SUMMARY OF SILICON ANOMALIES

The following table provides a summary of ADSP-BF561 anomalies and the applicable silicon revision(s) for each anomaly.

DETAILED LIST OF SILICON ANOMALIES

107. 05000471 - Boot Failure When SDRAM Control Signals Toggle Coming Out Of Reset:**DESCRIPTION:**

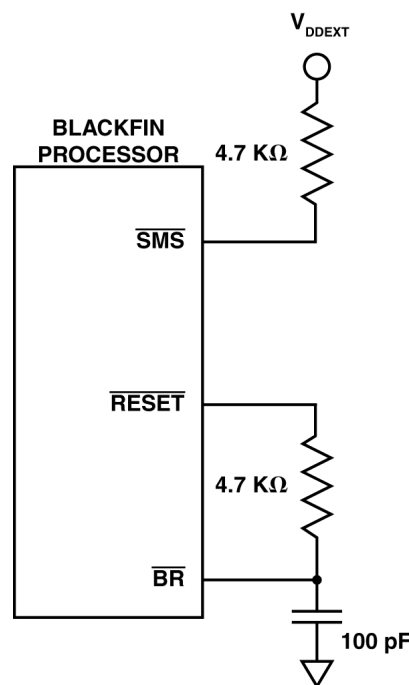
When $\overline{\text{RESET}}$ is de-asserted at the conclusion of the power-on reset sequence (not applicable to warm resets), there is a very small chance that the SDRAM control signals ($\overline{\text{SRAS}}$, $\overline{\text{SCAS}}$, $\overline{\text{SWE}}$, $\overline{\text{SMS}}$, $\overline{\text{SCKE}}$, and $\overline{\text{SA10}}$) may be driven low for a single CLKOUT cycle. This activity can cause certain SDRAM devices to enter engineering test modes that result in the SDRAM driving data onto the shared EBIU data lines that the Blackfin processor is going to read from when configured to boot or execute from parallel flash.

When booting from parallel flash (BMODE = b#01), this contention corrupts the boot stream and causes the processor to hang. At this point, power-cycling the processor is required to clear the condition.

When executing from parallel flash (BMODE = b#00), this contention corrupts the op-codes and causes the processor to execute incorrect or illegal instructions, which may result in improper application execution or unexpected exceptions.

The delayed version of $\overline{\text{RESET}}$ seen on $\overline{\text{BR}}$ causes the Blackfin processor to continue to three-state the SDRAM control signals after the rising edge of $\overline{\text{RESET}}$ for longer than one CLKOUT cycle, which over-rides the glitch behavior described by this anomaly. The pull-up resistor on the $\overline{\text{SMS}}$ pin ensures that the memory-select signal remains de-asserted while the processor is three-stating the $\overline{\text{SMS}}$ output. Additional pull-ups are needed on the $\overline{\text{AMSx}}$ signals as well. This drawing contains the local connections to the Blackfin processor only. The $\overline{\text{RESET}}$ input pin is connected to the reset supervisor circuit, and the $\overline{\text{SMS}}$ output pin connects to the SDRAM memory select pin.
